INTRODUCTION

This document has been produced in response to queries raised by MCC during the planning determination period, with regard to the removal of existing mosaic tiling around the ground floor, and the detailing and scope of new louvres.

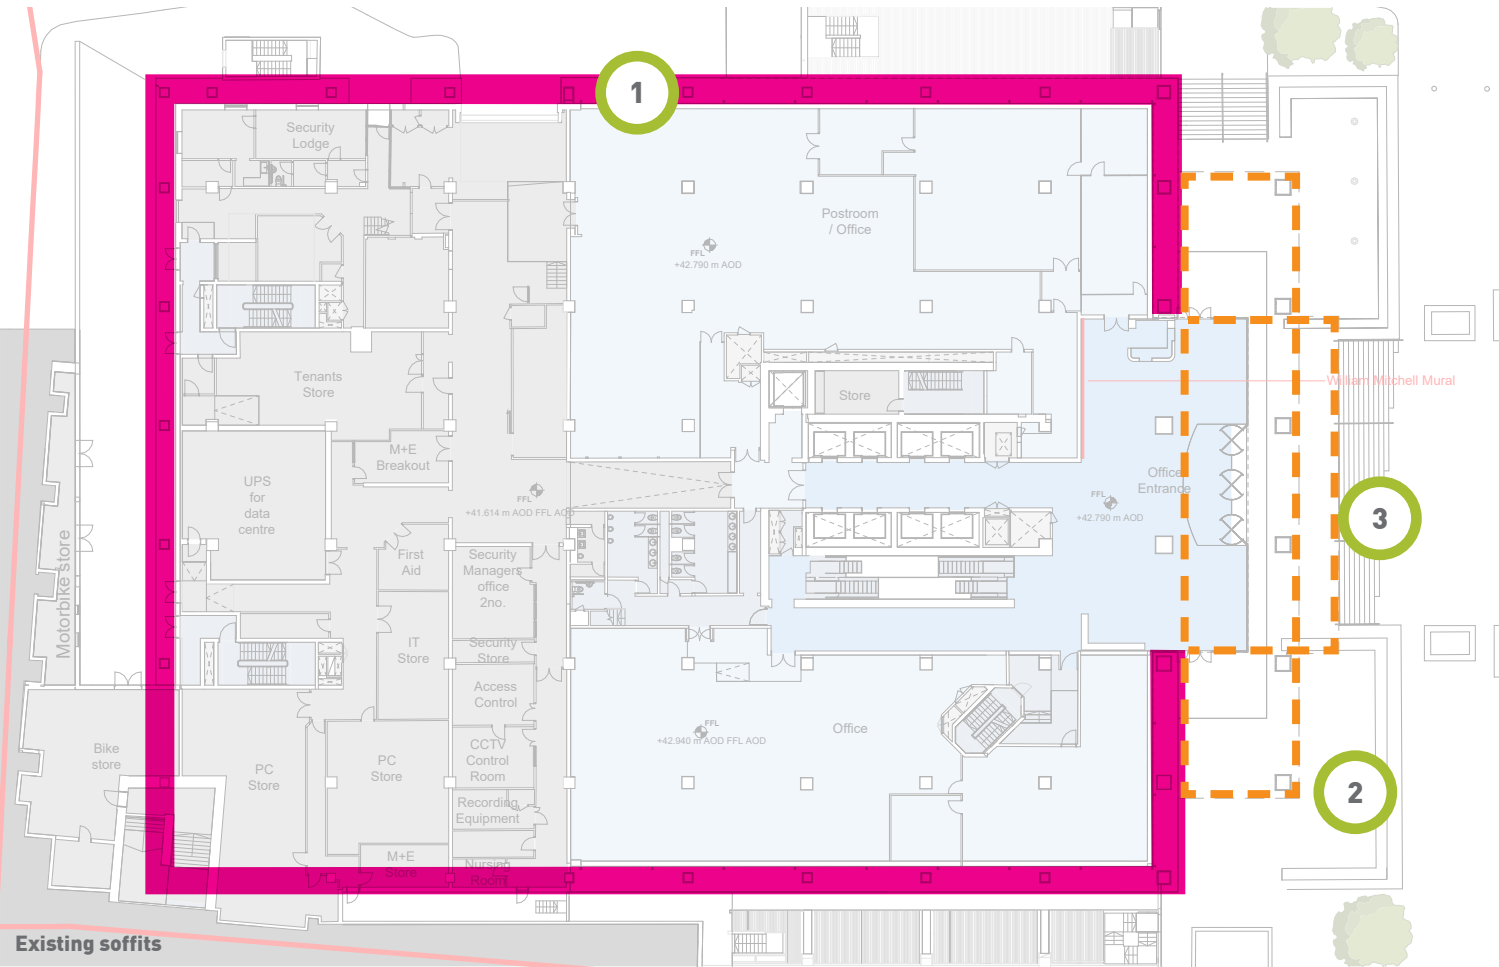
The adjacent diagram demonstrates the extent of mosaic soffit (underside of Level 01), in relation to the extent of hiduminium soffits around the Entrance Hall (underside of canopy and Level 02), which have varying details.

The varying materials and approaches to the soffits can be observed in close proximity to one another, around the main entrance. These are annotated using the numbers shown below, and provide context to the proposals described overleaf:

- 1. Mosaic soffit
- 2. Hiduminium soffit (detail 1)
- 3. Hiduminium soffit (detail 2)

The conceptual reasoning behind the three approaches is unknown, however it could be argued that whilst their differences are interesting, it also lacks coherence given the restraint and continuity of the detailing elsewhere.

Submitted eastern elevation with louvres highlighted

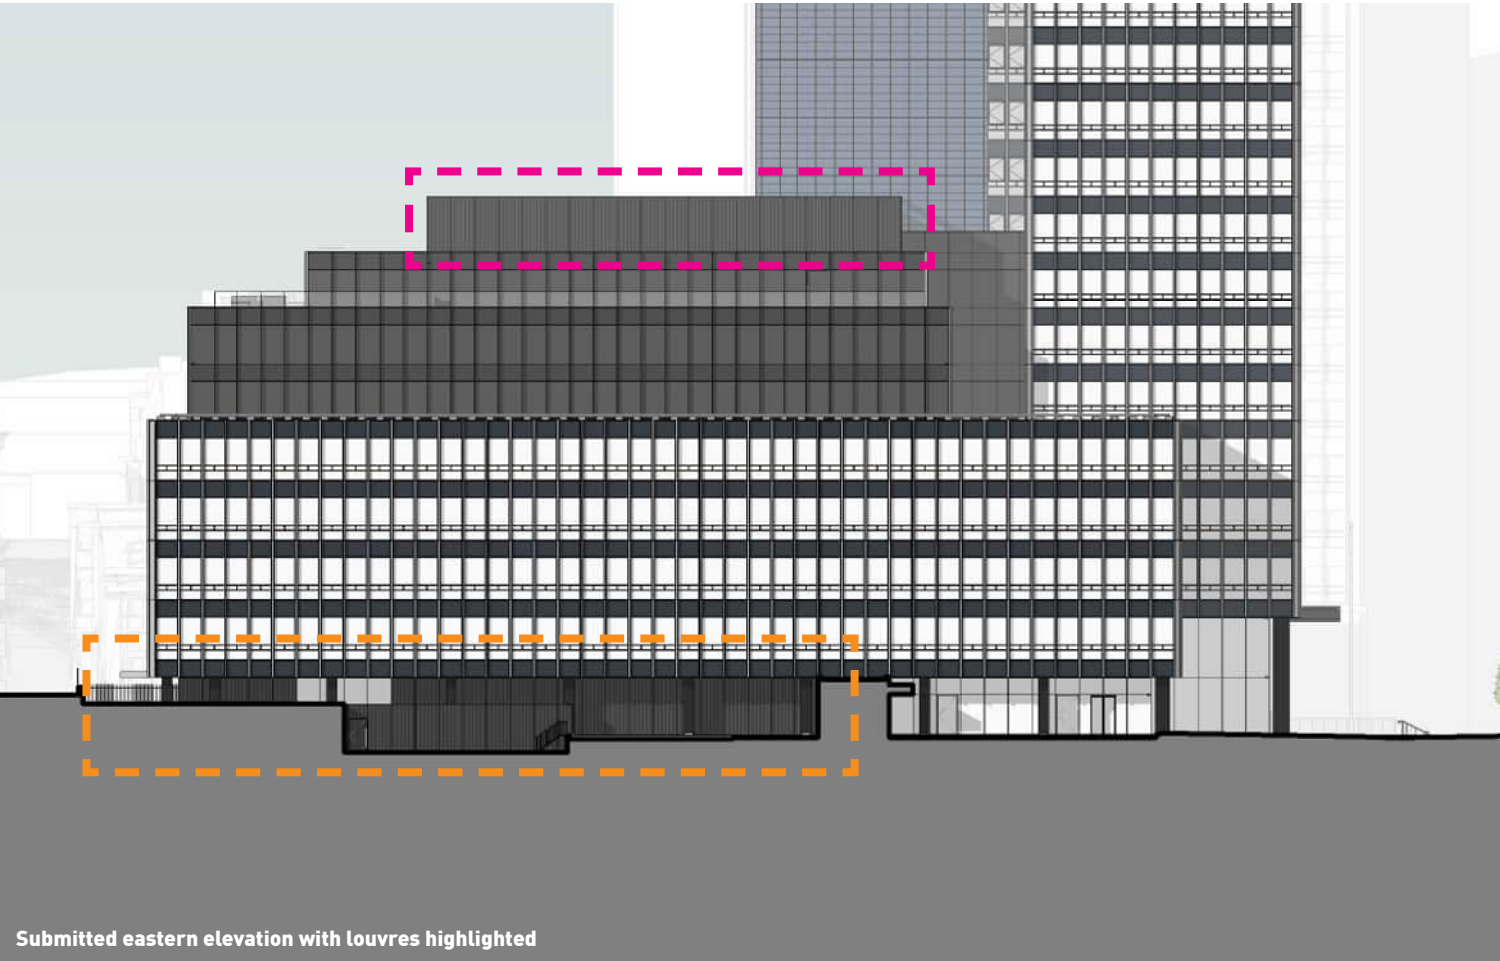
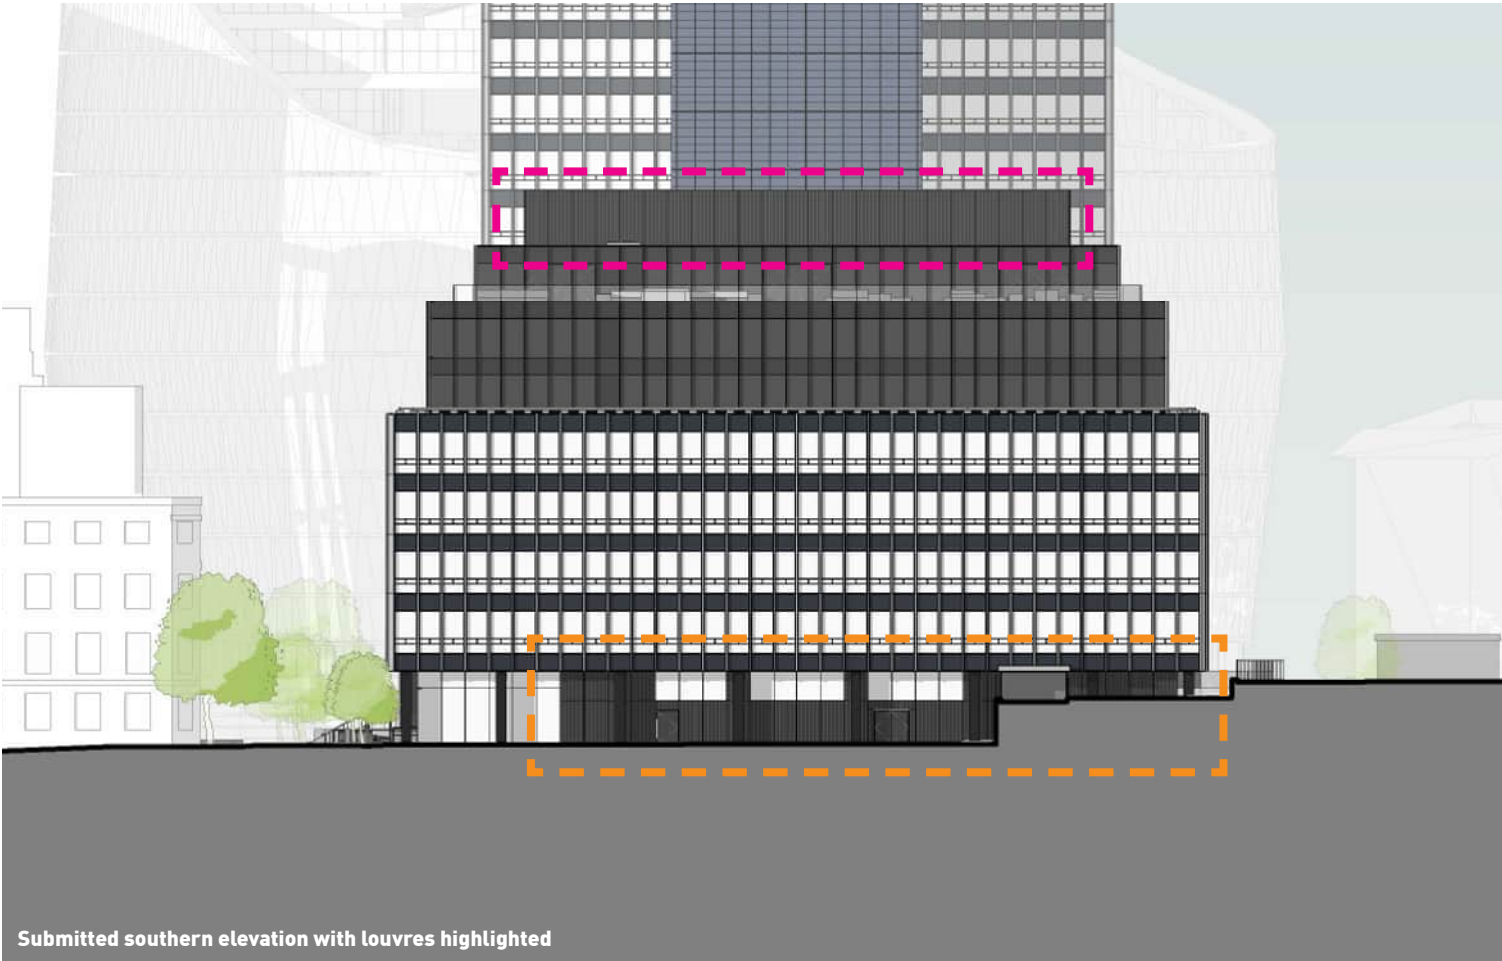
LOUVRE SCOPING

As part of the ground floor remodelling and recladding works, which include facade performance benefits, the existing walls and the mosaic finish are proposed for removal. In their place, a vertically orientated louvre system in a black PPC finish is proposed. This system expression would be largely decorative, with a solid, colour matched backing panel. The areas for this approach are indicated in the orange boxes below.

The approach described above is consistent with the detail proposed for the podium extension plant enclosure. This area would use the same vertically orientated louvre system in a black PPC, without a backing panel, to enable air flow around plant equipment. The areas for this approach are indicated in the pink boxes below.
